UNITED STATES PATENT AND TRADEMARK OFFICE

APPLICATION NO.	FILING DATE	FIRST NAMED INVENTOR	ATTORNEY DOCKET NO.	CONFIRMATION NO.
10/761,996	01/21/2004	John D. Phillips	25003B	4300

Office Action Summary

MARKED DRAWING
FOR APPLICATION
10/761996
Des. 369,421

FIG. 1

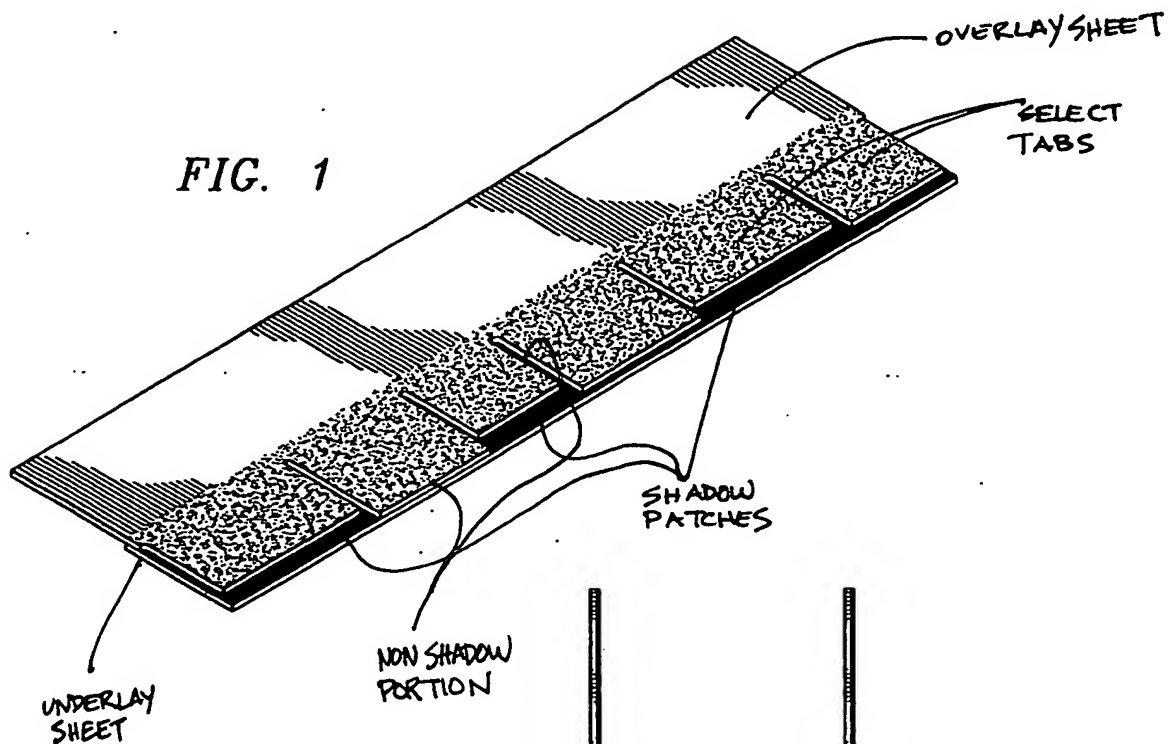
Regarding claims 14 and 18, Kiik discloses a variably (random) cut shingle (see title) having an overlay sheet and underlay sheet (marked fig. 1), each overlay sheet having a plurality of select tabs and the underlay sheets having a plurality of shadow patches (marked fig. 1). Kiik also discloses the tabs as covering portions of the patches (fig. 2). In addition, Kiik discloses a portion which can be construed as a non shadow portion (marked figure) which, together with the shadow patches and remainder portions cause the shingle to appear as varying.

FIG. 2

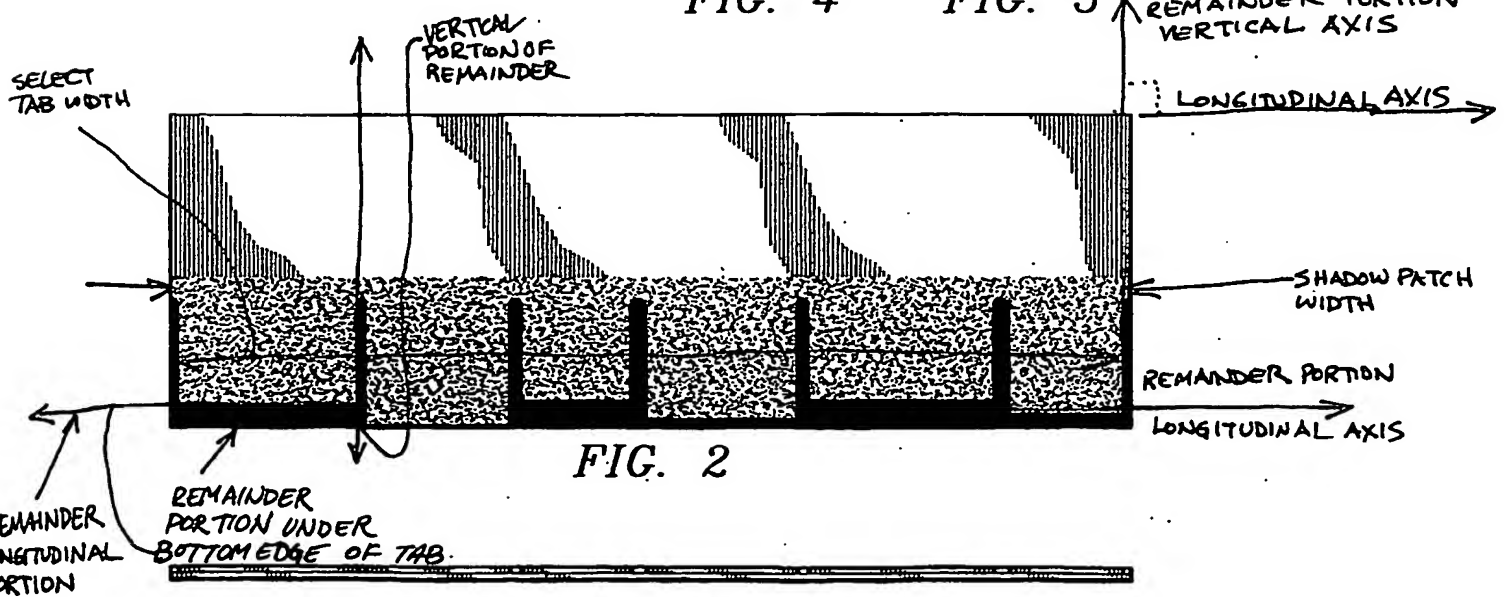
Regarding claim 15, Kiik discloses a remainder portion visible under a bottom edge of a tab (marked fig. 2).

Regarding claim 16, Kiik discloses the shingle as having a longitudinal axis and the remainder portion as having a vertical portion perpendicular to the shingle axis (marked fig. 2).

Regarding claim 17, Kiik discloses the longitudinal axis of the remainder portion as being parallel with the longitudinal axis of the shingle (marked fig. 2).

Regarding claim 19, Kiik discloses a shadow patch width as disposed along the longitudinal width of the shingle (marked fig. 2). Kiik also discloses the shadow width (marked fig. 2) as being longer than the tab width (marked fig. 2). Kiik also discloses the patches and tabs alternating along the length in a synchronized manner (fig. 2).

Regarding claim 20, Kiik discloses the two sheets as laminated together (figs. 3-5) and tabs covering partial portions of patches (fig. 2).

Regarding claim 21, Kiik discloses the remainder portion (marked fig. 2) as being established by the varying lengths of the tabs and patches (marked fig. 2).

Regarding claim 24, Kiik discloses the remainder portion as having a longitudinal portion which is parallel to the shingle longitudinal portion (marked fig. 2).
